Access Compliance Report Public Rights-of-Way (Curb Ramps)

Main Street: MILNEBURG_ST Cross Street: KENNELLY_LN Location: NE

ADA ID: RPRK210924125317 Ramp Type: Type 1 - Perpendicular Diagonal Initial Pass/Fail: Fail Overall Compliance: No Severity Score: 32

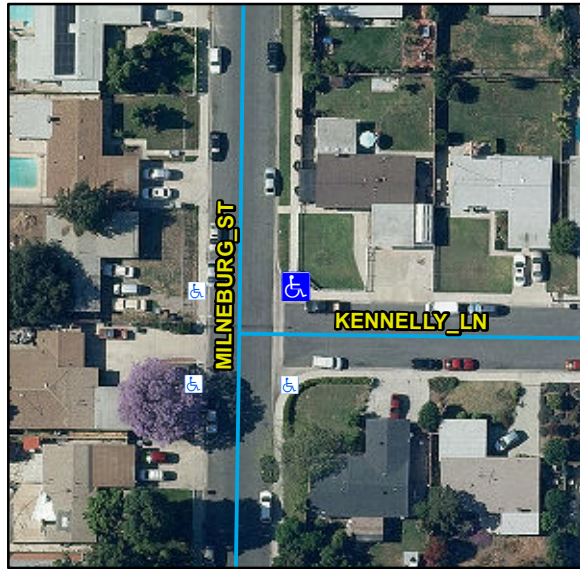
Compliance	Description	Data	Compliance	Description	Data
N/A	Ramp Length (in)	50	N/A	Flare Type LT	
Yes	Ramp Width (in)	48			N/A
No	Ramp Run Slope (%)	13.2	N/A	Flare Slope LT (%)	N/A
Yes	Ramp Cross Slope (%)	1.5	N/A	Flare Traversable LT	N/A
N/A	Landing Present	N/A	N/A	Flare Type RT	
N/A	Landing Length (in)	N/A			N/A
N/A	Landing Width (in)	N/A	N/A	Flare Slope RT (%)	N/A
N/A	Landing Run Slope (%)	N/A	N/A	Flare Traversable RT	N/A
N/A	Landing Cross Slope (%)	N/A	N/A	DWS Provided	N/A
N/A	Landing Movement Obstructed?	N/A	N/A	DWS Contrast	N/A
	Landing Movement Type	N/A	N/A	DWS Length (in)	N/A
N/A	Landing Shared	N/A	N/A	DWS Full Width	N/A
N/A	Clear Space	Yes	N/A	DWS Offset Left (in)	N/A
N/A	Clear Space To Crosswalk (in)	N/A	N/A	DWS Offset Right (in)	N/A
N/A	Marked Crosswalk 1	No	N/A	Marked Crosswalk 2	No
	Crossing 1 Direction	W		Crossing 2 Direction	S
	Marked Crosswalk 1 Width (in)	N/A		Marked Crosswalk 2 Width (in)	N/A

Remove & Replace Curb Ramp With Two New Directional Ramps or Equivalent.
